Review and Progression  
of  
802.1AB-d1.0  
Paul Congdon

# Interesting changes since d0

# Architectural Diagram

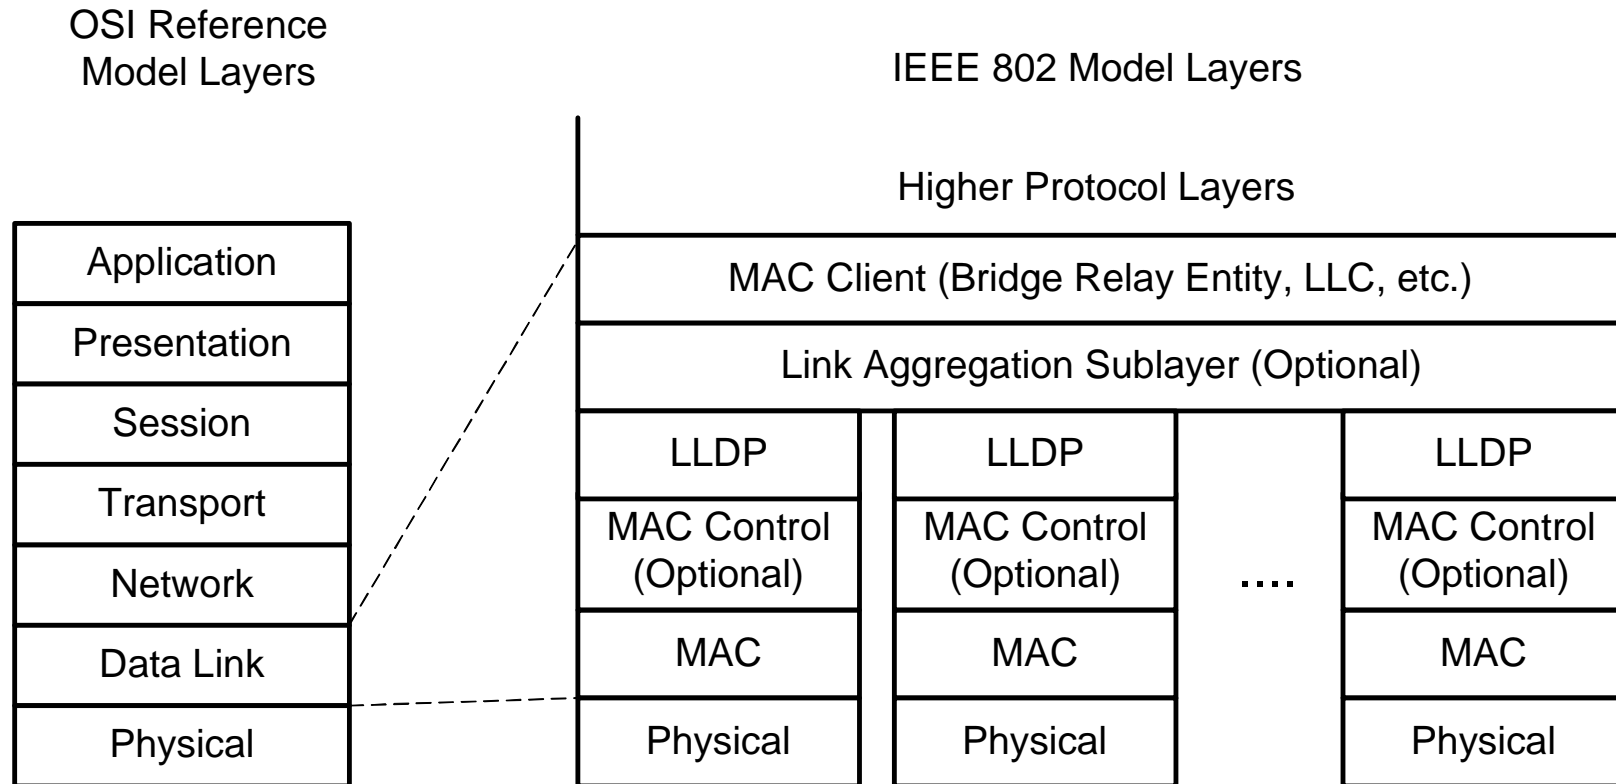
# Discussion #1: Architecture Diagram

- Diagram shows where protocol fits with respect to link aggregation, but doesn't depict controlled vs uncontrolled port.
- Consideration of running over uncontrolled port
  - Advertising information that could be valuable to 802.1X authentication procedure (e.g. Network Service Identifiers)
  - Alternatively, it could be part of 802.1X in the Req/ID exchange.
  - Why do we want to mandate that this run on the controlled port only?

# Discussion #5: TLV type definitions

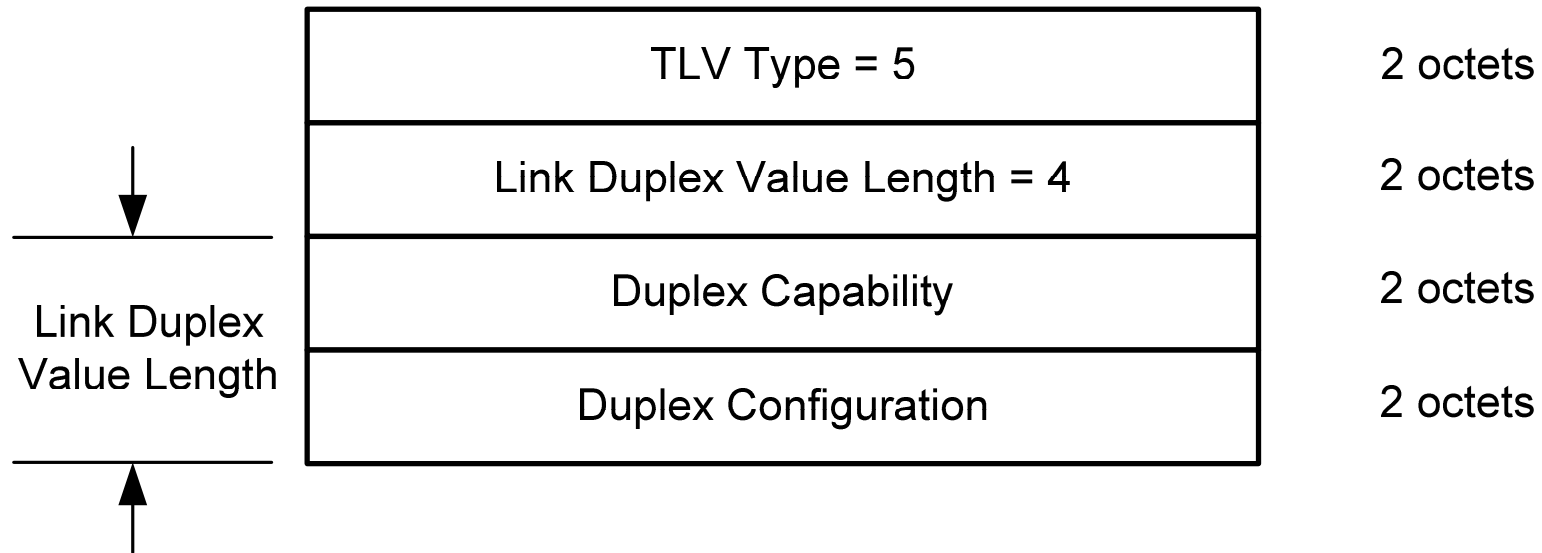
- Current TLV types distinguish mandatory verses optional. Mandatory types are lower values.
- Should we separate and reserve space for future mandatory definitions or let new values be defined sequentially as needed?
- Recommendation:
  - Define as needed. Range checking isn't that critical to implementations.
